Subject: AP1000 COL Standard Technical Report Submittal of APP-GW-GLN-131 (TR 131),
Revision 0

TITLE: Miscellaneous AP1000 Design Changes

Technical Report 131 addresses a few miscellaneous design changes made to AP1000 that are incorporated into Revision 16 of the Design Control Document.

Figure
2.3.11-1
Gaseous Radwaste System

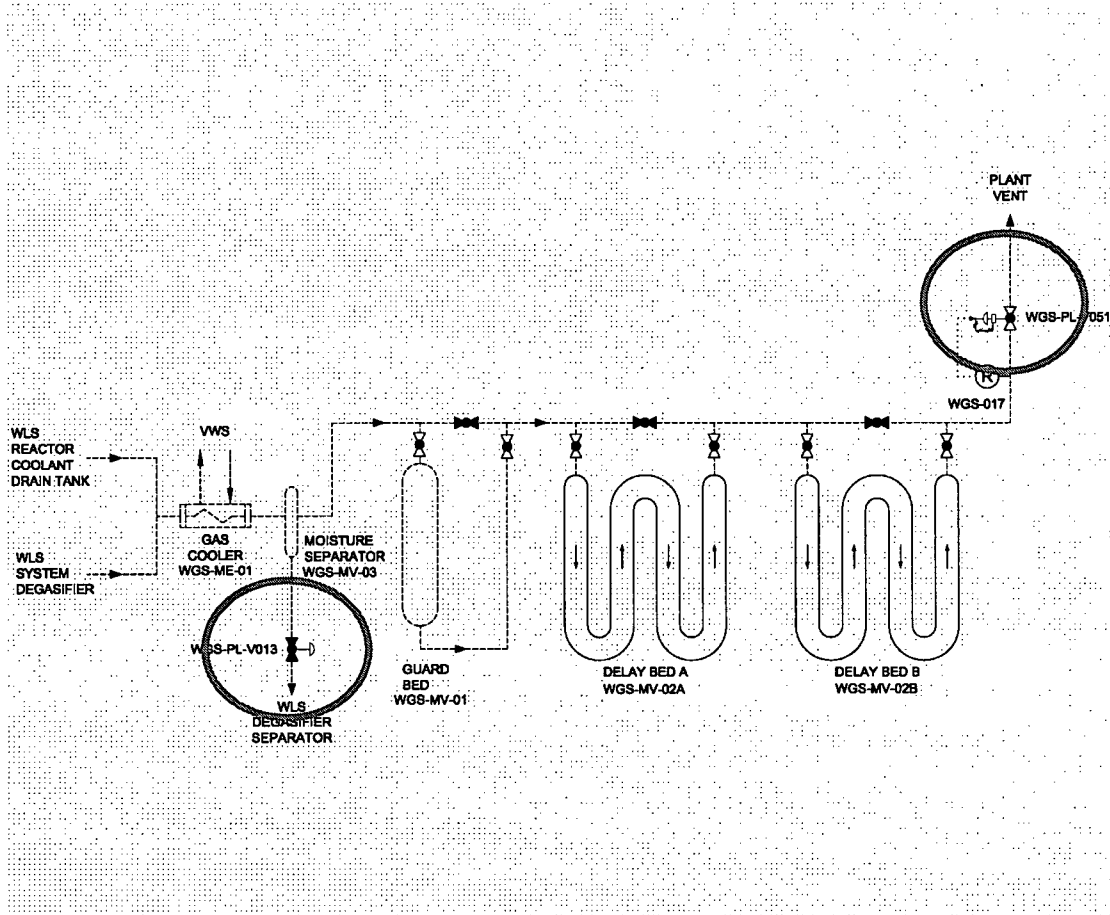
Change 1: WGS Simplified Sketch Corrections

The current version of the Gaseous Radwaste System (WGS) simplified sketch shown in the DCD does not accurately depict the current status of the WGS design. The sketch will be updated to reflect the current AP1000 WGS design by correcting the valve type for the discharge valve and the moisture separator drain valve.

Figure 9.5.1-1 (Sheet 1 of 3)
Fire Protection System
Piping and Instrumentation Diagram
(REF FPS 001)

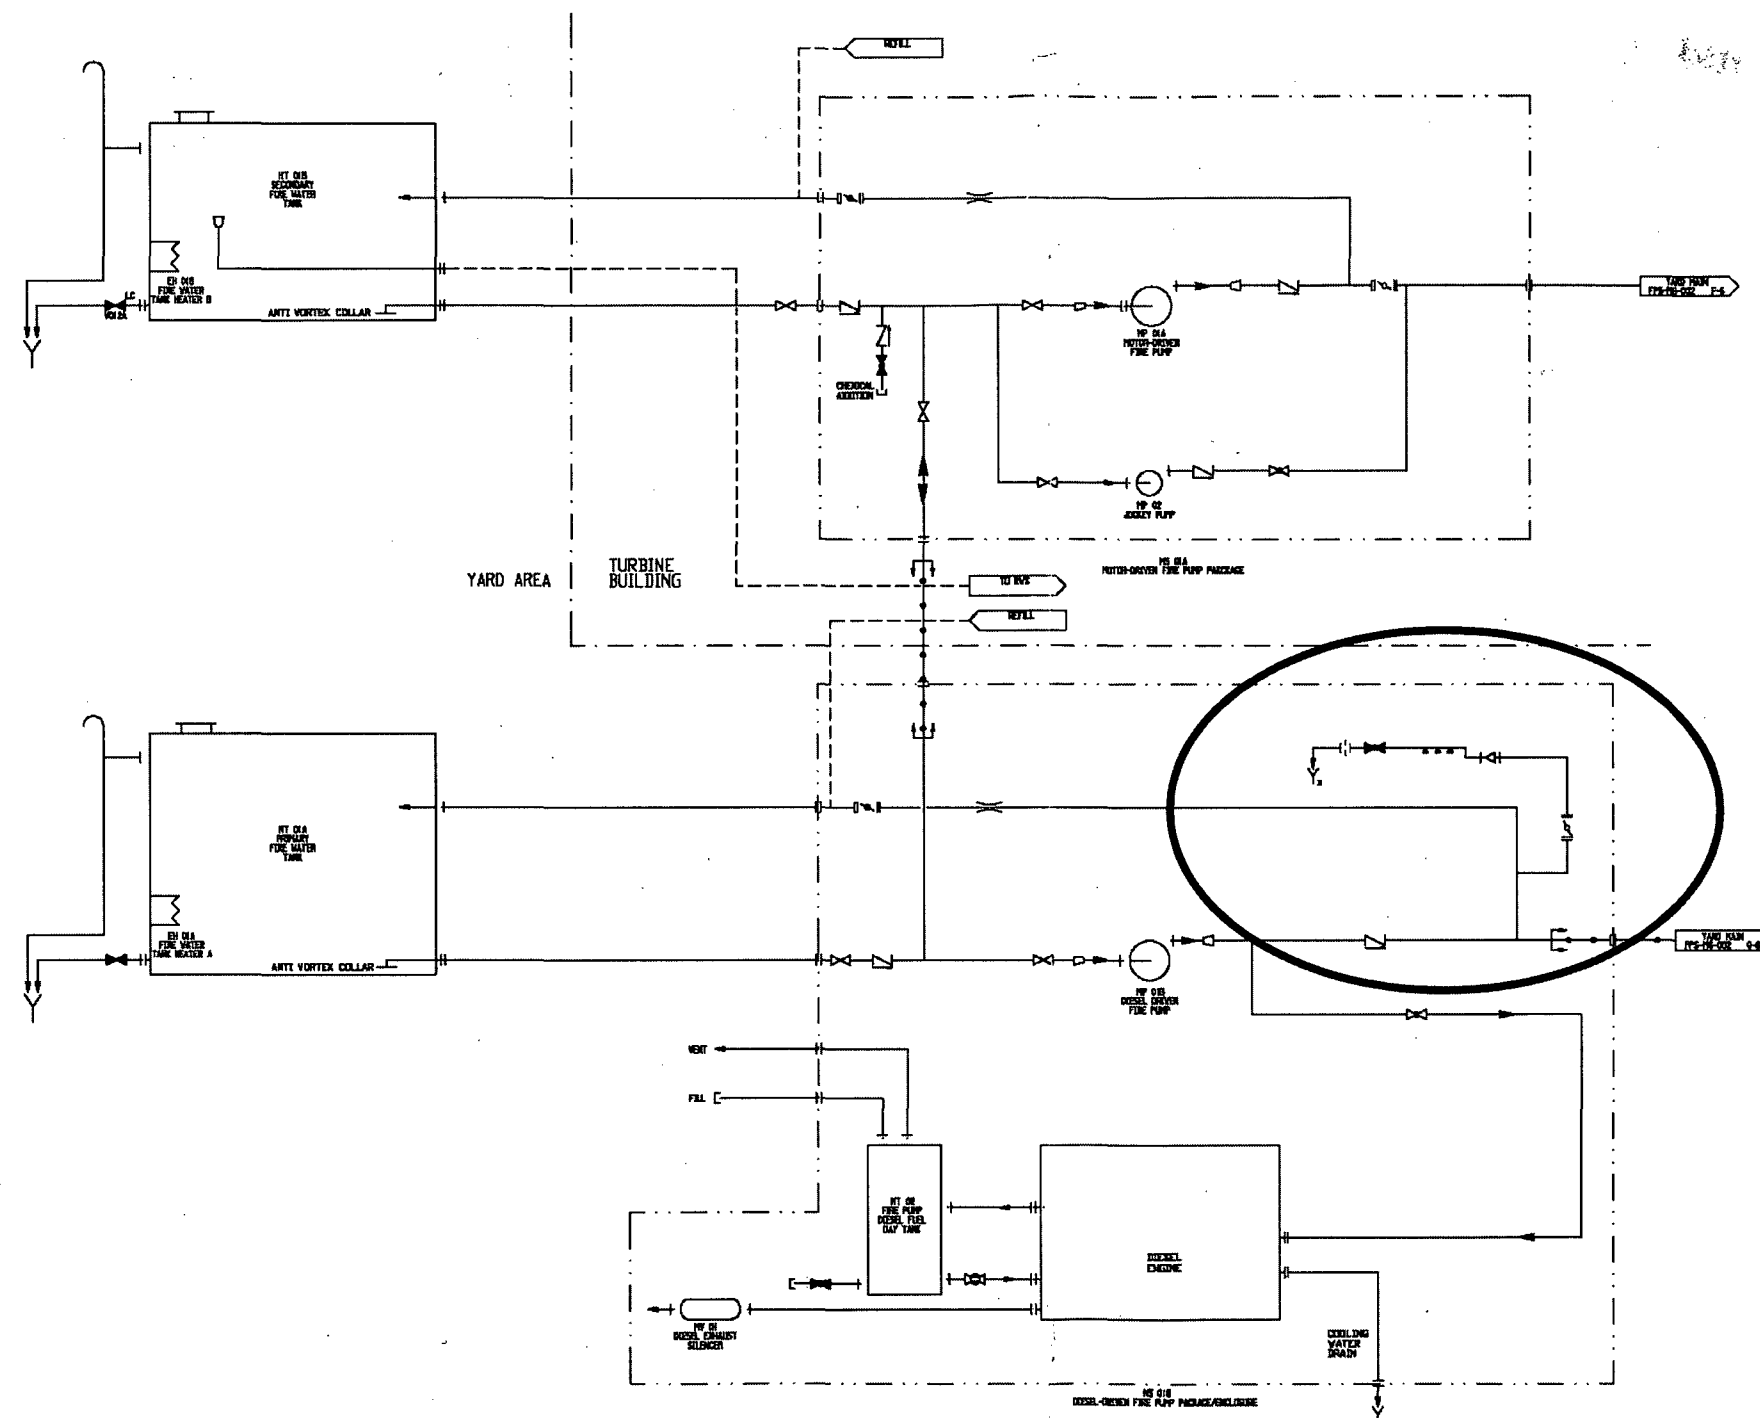
Change 6: Addition of sprinklers that exist in the diesel driven fire pump enclosure

The current design has sprinklers in the diesel driven fire pump package. The figure included in this TR shows these sprinklers.

Figure 9.5.1-1 (Sheet 3 of 3)

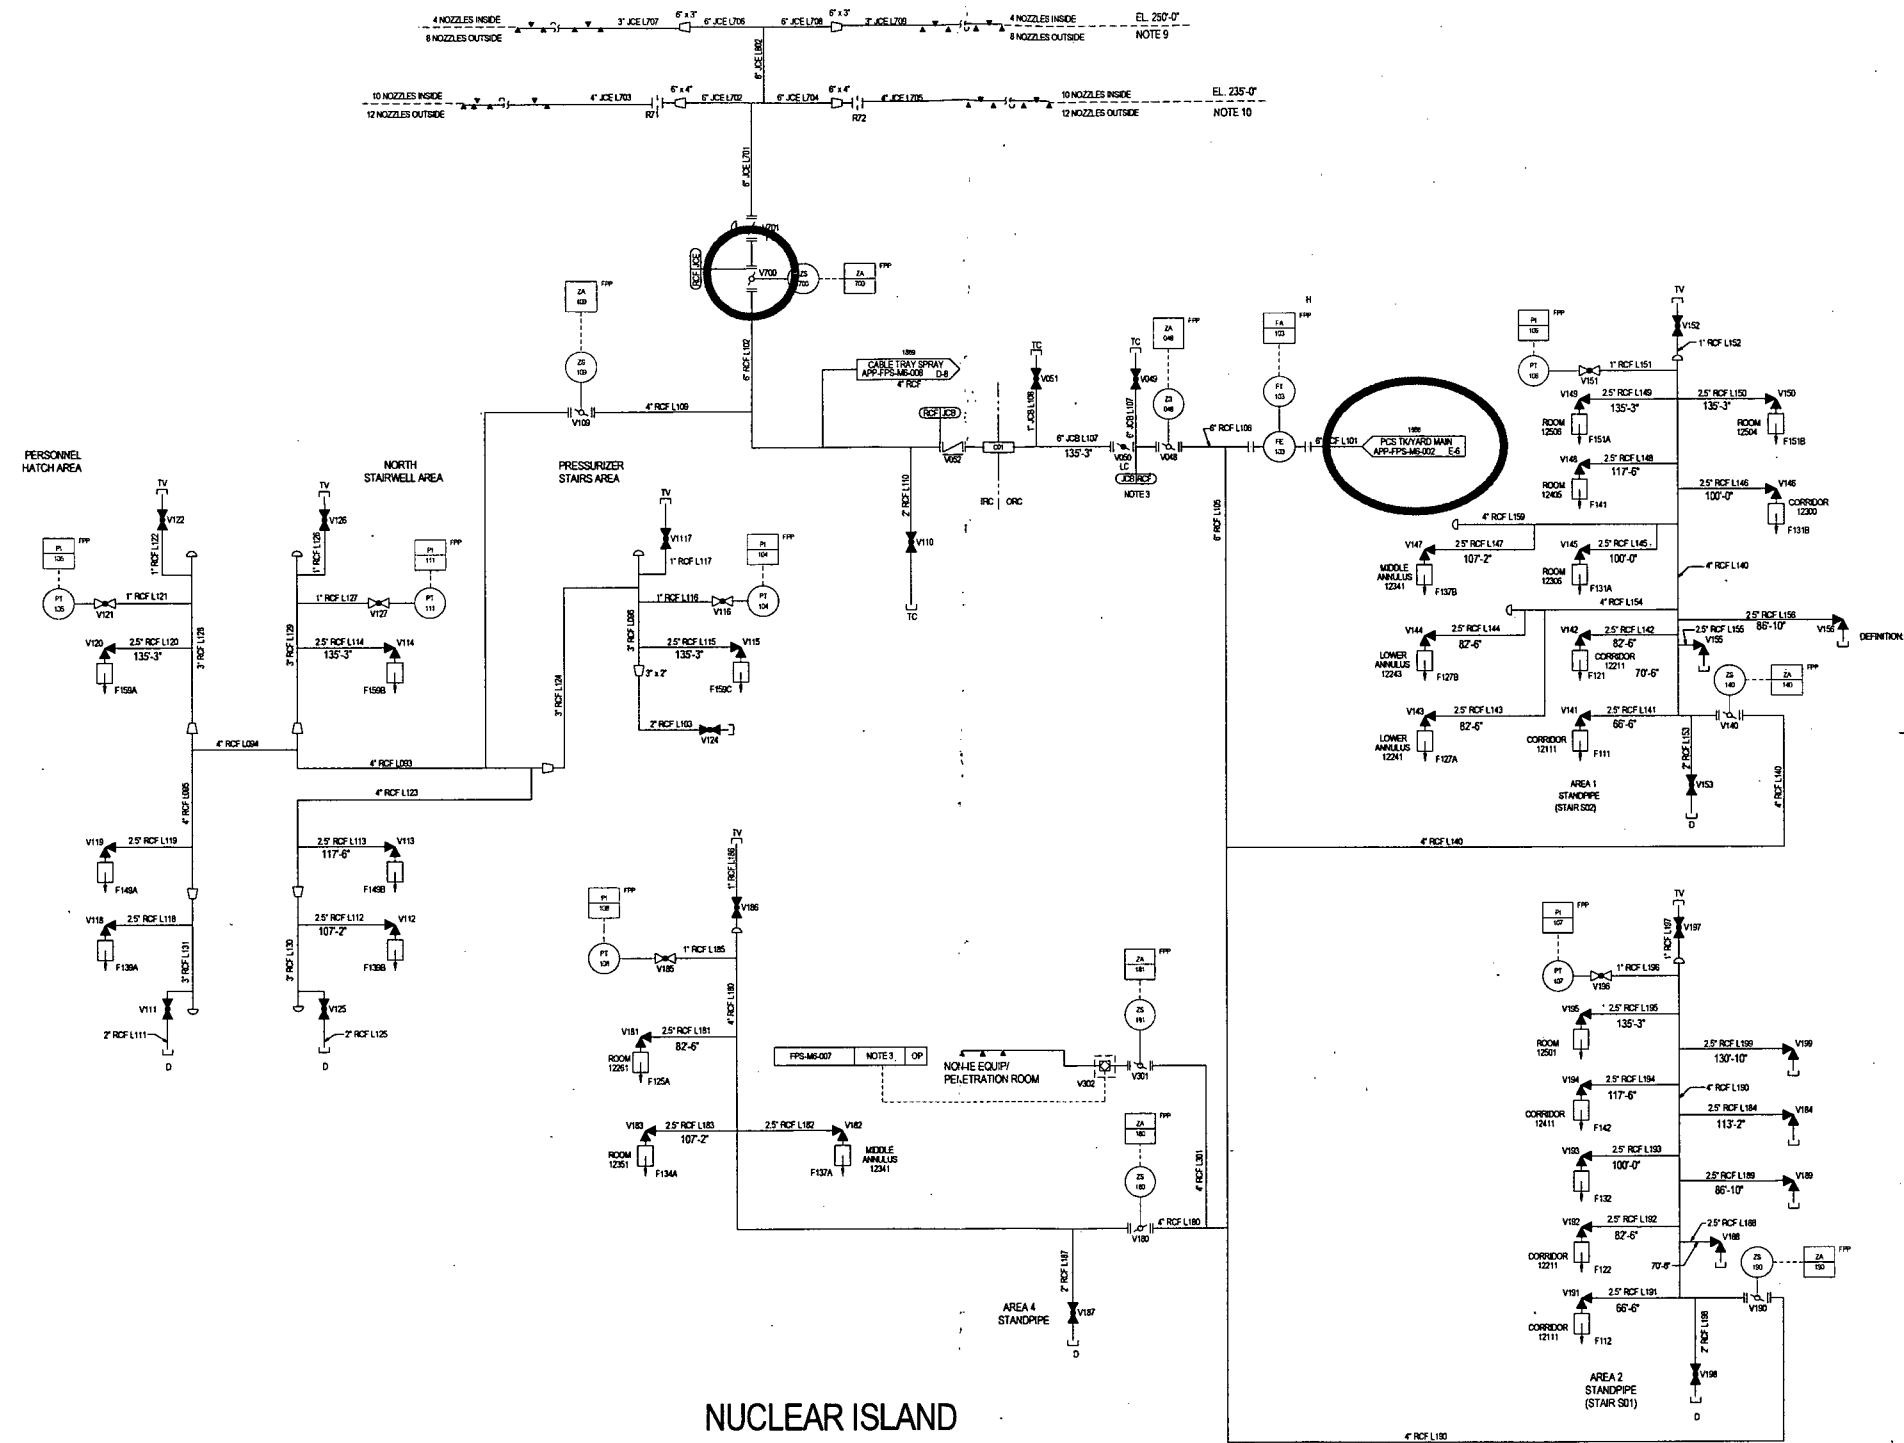
Change 7: Correction to Sheet 3 of Figure 9.5.1-1

The current figure is incorrect in the following ways:

- Valve V102 is incorrectly labeled, it should be valve V700
- Flag coming from "FPS TANK" is changed to show its correct origin
